PCN # ESW490-47 – Thyristor & Diode SOT-227 Packaging Location Transfer

Product/Process Change Notice (PCN)

PCN Report

Padless type (DCB based Assy)

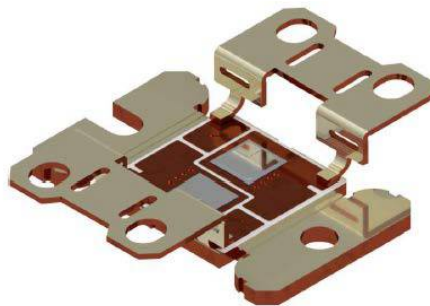
- 1) Small part numbers changed Assy process from Pad type to Padless type. Padless type is widely used for other SOT-227 package part numbers and is considered as a process improvement during the transfer.

Detail changed part numbers pls refer to Appendix B - Pad Type to Pad Less DCB Part List
